TOLERANCE X.X = ± .060 X.XX. = + .030	316 Stainless Intermediate Post, Stainless Steel, 2.00 Inch Square x 0.12 Inch Wall, 42 High,Brushed S Finish,Grade 316,Embed Mnt,Flt Plt					
XX = ± .030 XXX = ± .010 X° = ± 1°	Satin Brushed	DATE: 9/5/2019 DRAWN BY: T. Kolbach	REV:	> UIAGNER		
UNLESS OTHERWISE NOTED	WEIGHT: N/A	ITEM NUMBER: LG32242DN	1EM.4	COLLABORATIVE METAL WORKS

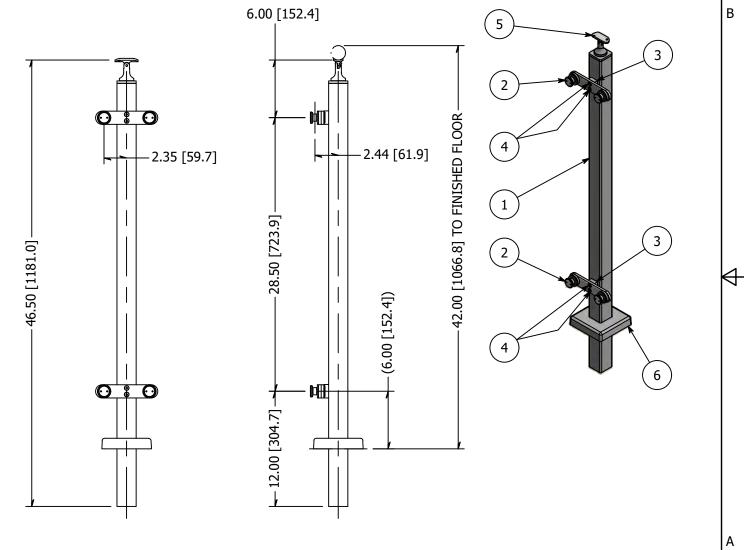
REVISION HISTORY						
REV	DESCRIPTION	DATE	APPROVED			
	Wall Thickness was changed from 0.25 to 0.12 and the					
2	corner radii from .375 to .188 on the square post.	3/13/2019	ATM			
	ADDED (1) ITEM 6 (P/N LG322SMC).
